# **Running Change Notice E-119 Tri+ Disc**

# **Forks**

# Running Change Notice E-119 Tri+ Disc

# **Stem Cap**

Previous New

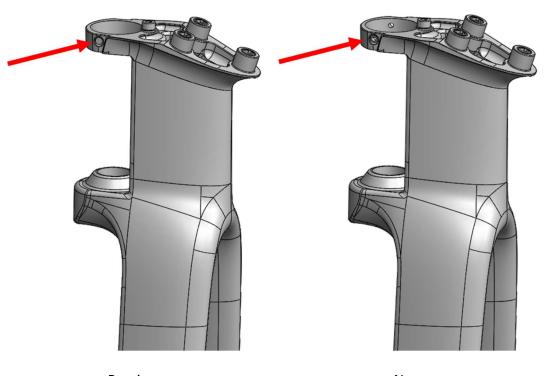
The fork stem was modified to change the assembly method of the stem cap. Previously, rubber plugs protruding from the stem cap sat within recesses on the fork that held the stem cap in position. For the new configuration, threaded holes were added to the fork that allow for the stem cap to be assembled with M3\*6mm flat head screws.

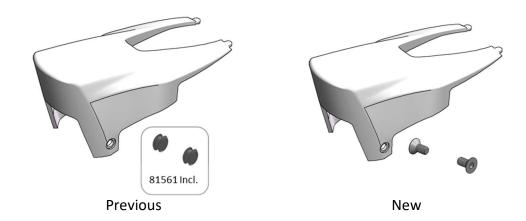
The stem cap PN81560 was modified to include two M3\*6mm flat head screws. Also, the rubber plugs (PN81561) were removed from the stem cap kit and will only be available as a separate part (pair).

Figures below show the previous and new configurations of PN81560.

Refer to Section 14.7 of the Assembly Guide for the installation of the stem cap on the bike, available here:
